Kansas Department of Agriculture
 Division of Water Resources
CHANGE: P/U WORKSHEET

RE: Field Office Application for Change
Water Right, File No. 32381

CHANGE IN PLACE OF USE WATER RIGHT, FILE NO. 32381

RE: Application for Change in Place of Use
Water Right, File No. 32381

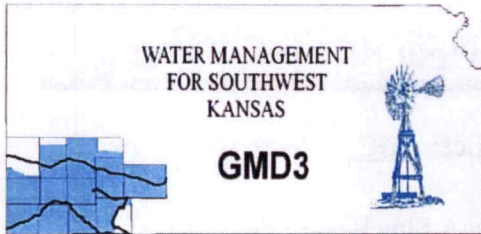
We have reviewed the application for the above referenced water right. The proposal is not in conflict with the Management Program of the Southwest Kansas Groundwater Management District No. 3 (GMD3). The proposed change in place of use will increase authorized acres by 8 acres, which is the 10% allowable increase, in accordance with K.A.R. 5-5-11(b). It is therefore recommended that the application be approved at this time.

Is Proposed PU overlapping existing WRs? WR will remain alone, no overlap.

Proposing to move acres to a small 88 acre pivot, with 22 acres in each of the subquarters in the NW still.

Proposal would increase acres by 8, which is within the allowable 10% in this case.

Recommendation: After review of all available information, appears current area rules are met. Staff recommends approval of the application.
